**CONDITIONS FOR CASK USE AND
TECHNICAL SPECIFICATIONS
DOCKET NO. 72-1007
CERTIFICATE OF COMPLIANCE NO. 1007
AMENDMENT 3**

REVISION HISTORY

FIGURE 1

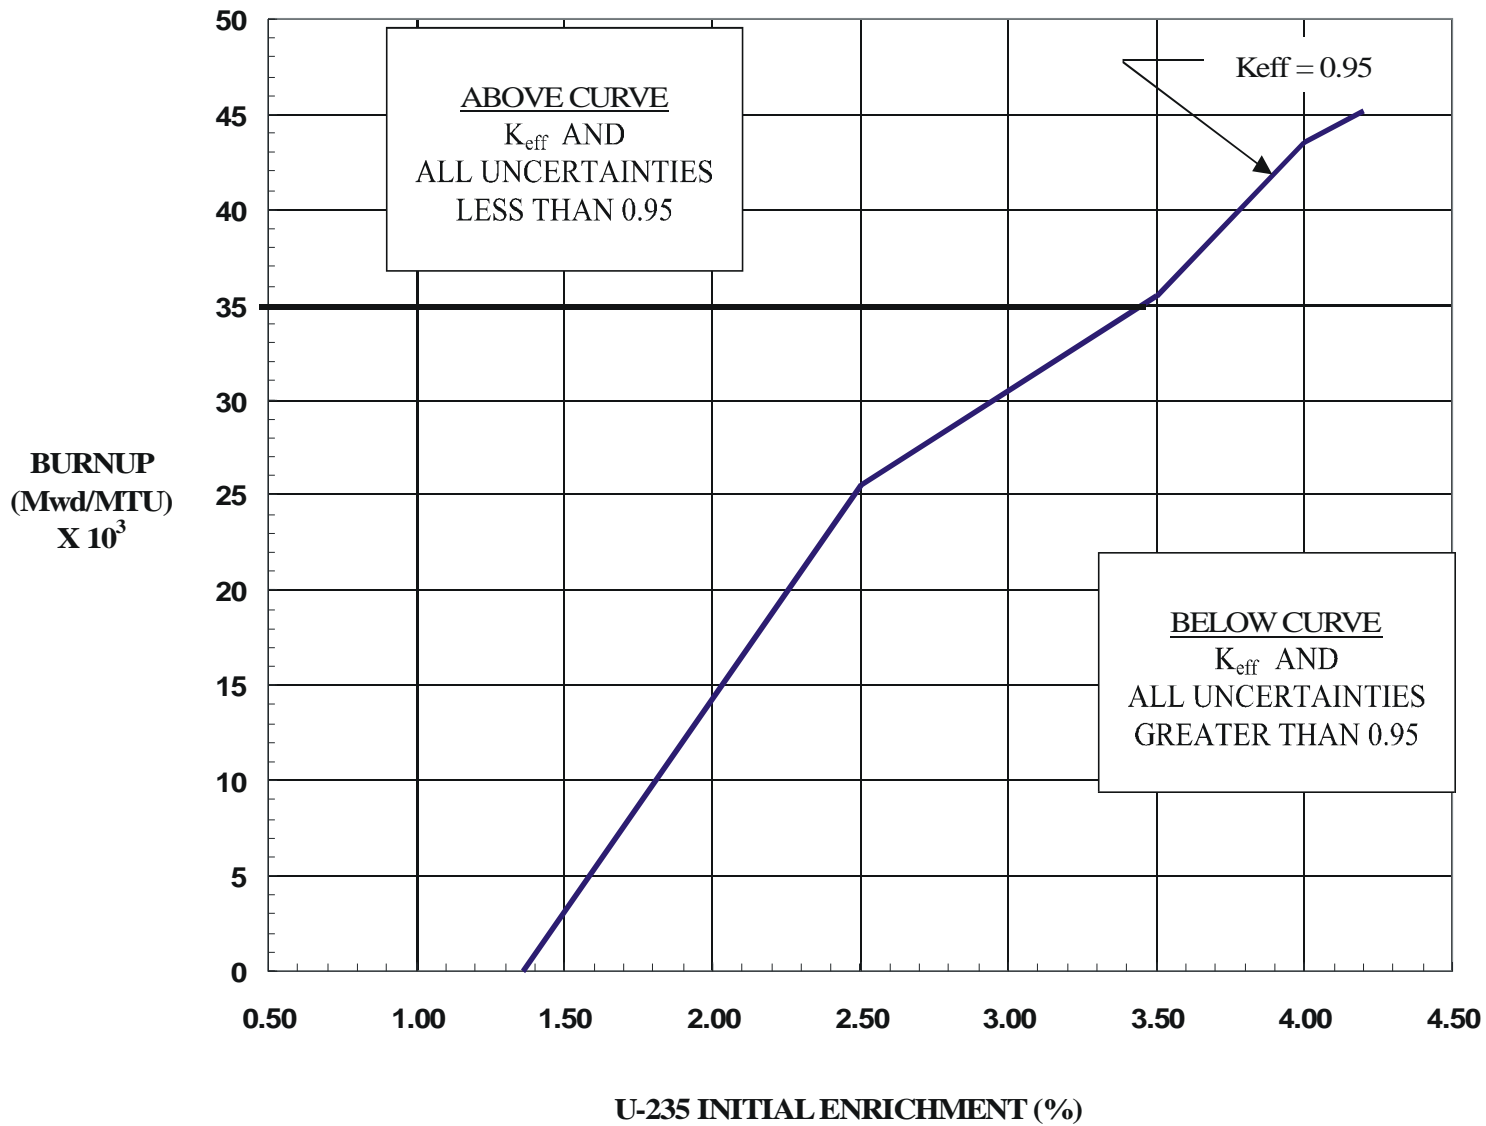
Section	Change Description
Amendment 3	All	Removed "Basis" of specification from all sections.
	1.2.1	Revised text to eliminate use of Figure 1 for CE 16X16 fuel and corrected typographical error in Figure 1.

Figure 2
B&W 15x15 Fuel Boron Concentration Curve

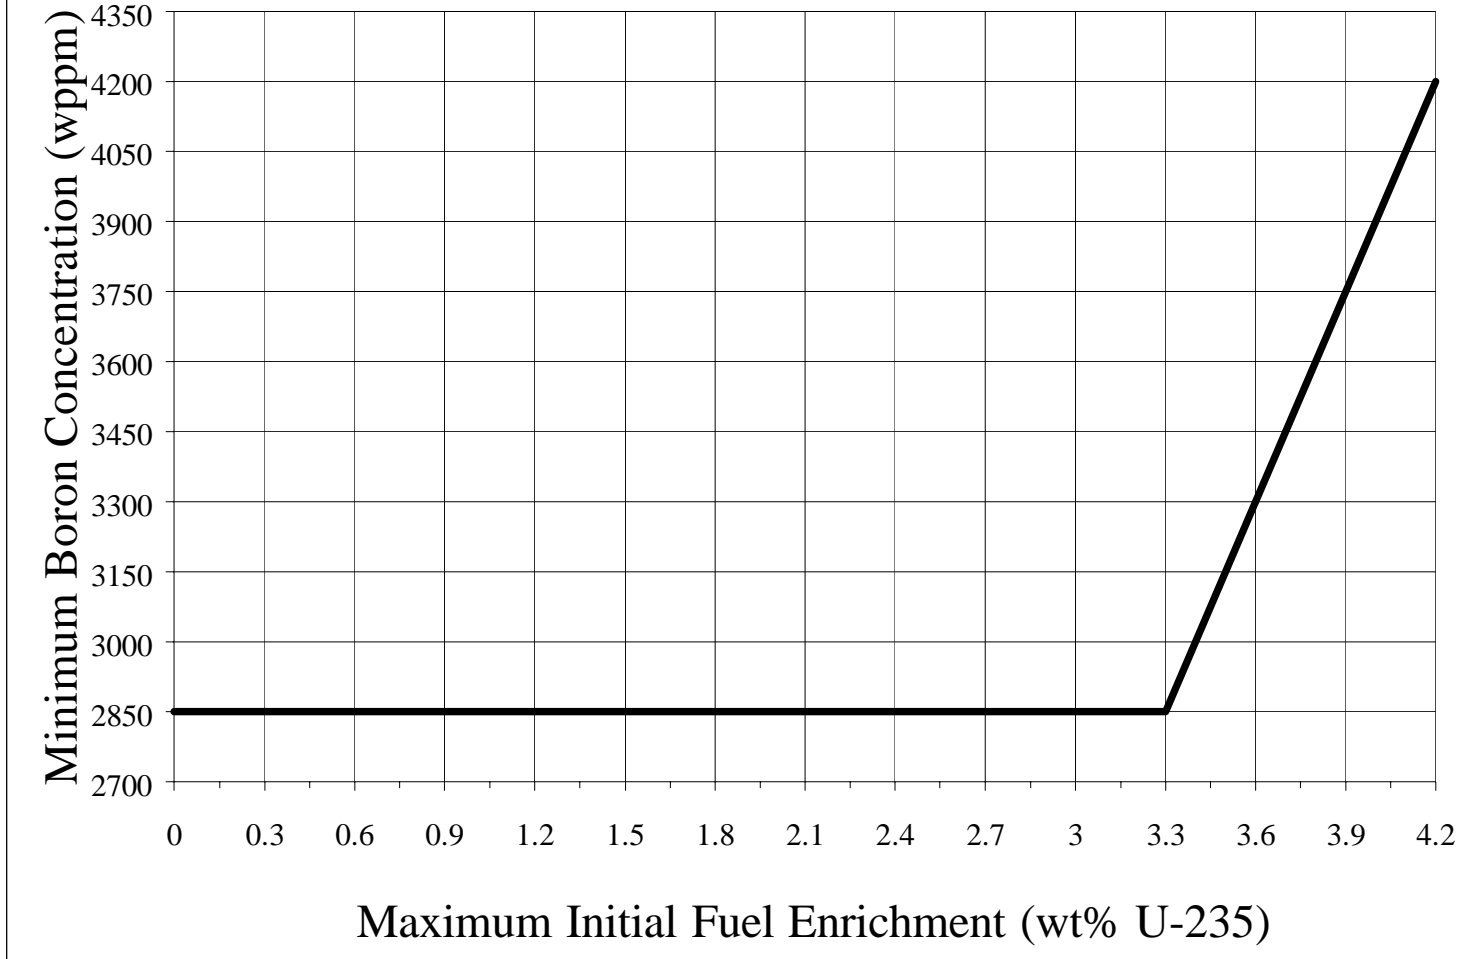
1.2.6	Revised title of Figure 2 to refer to B&W 15X15 fuel, added Figure 3 for CE 16X16 fuel, and added appropriate references in text.
	1.2.7	Revised text from "...shield lid plug..." to "...shield lid fitting...."
Amendment 2	1.0	Corrected typographical errors.

The MSB cavity shall be filled only with water having a boron concentration equal to, or greater than, 2850 ppm. The higher concentration of either 2850 ppm or that specified in Figure 2 shall be used when loading or unloading MSBs with B&W, Mark B, 15X15 fuel containing BPRAs, or Figure 3 when loading or unloading MSBs with CE 16X16 fuel.
